Appendix B2

Independent Geotechnical Expert Review Panel Reports

**Report No 11
Meadowbank Mine Dike Review Board
Meeting April 11-12, 2012**

SUBJECT: RESPONSE TO REPORT no.11 MEADOWBANK DIKE REVIEW BOARD

Photo #13 Bay-Goose Dike, channel #1

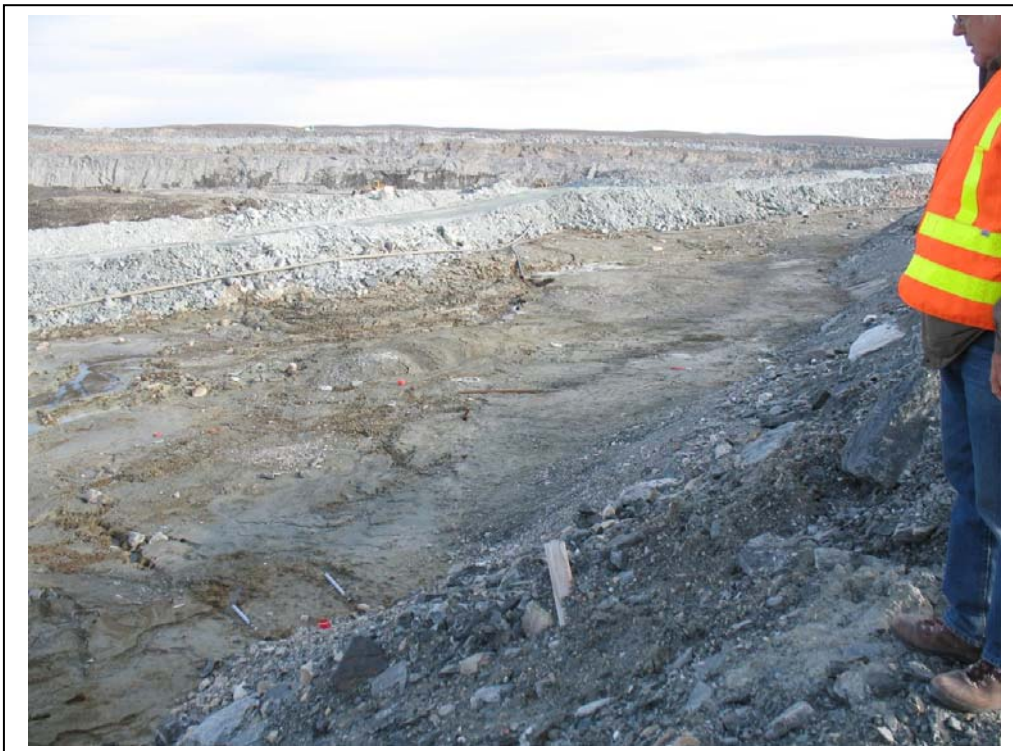
Many are undoubtedly minor. The Board's major concern is in the area denoted as Channel 1 (Stns 32+020 to 32+100) where a number of abnormalities come together to indicate a need for closer examination. These include:

- Piezometer records (series 29 at 32+105 exhibits greater fluctuation than others in the region);
- Inclinator profiles (No. 8 at 32+065);
- Observed seepage (investigation by Patrice Gagnon);
- Thermistor warming (T29 in the rock).

It is to be noted that this area also coincides with an adverse curve in the dike axis and a relatively steeply dipping lake bed. Preparedness for potential deterioration is warranted.

Photo #17
East wall of Bay-Goose pit

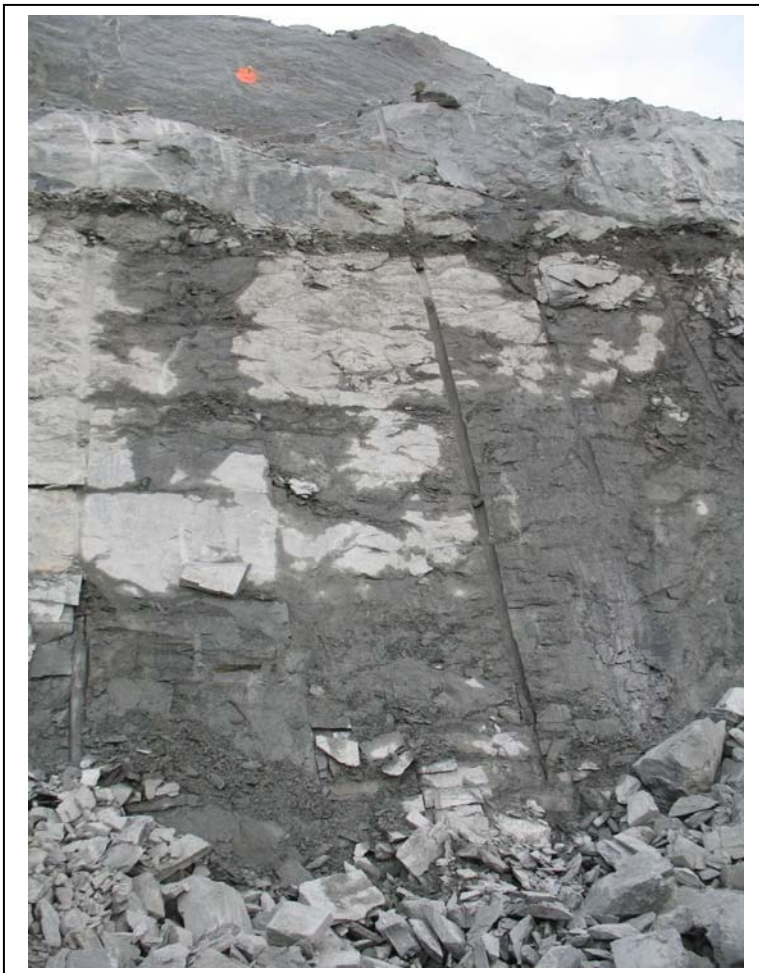
should not be ignored when introducing the benefits of rock bridging. The Board recommends that a setback of 70 m be maintained but that the opportunity for steepening the slope from 43° to one at 49° to 53° be explored once the rock face has been adequately exposed to permit discontinuity mapping and when measurements are made of the real water pressures. There is therefore a pressing need to instrument the pit walls with priority given to the east face. Instrumentation should include deep piezometers in holes dipping to beneath the lakebed to permit installation along the dike centerline, as well as an adequate number of survey monuments/prisms on the rock of the in-field area and on the pit face. TDR arrays have also been suggested. Thermistors would also be useful to record freeze-back of the pit wall that could hinder drainage and result in elevated pressures within the rock wall.
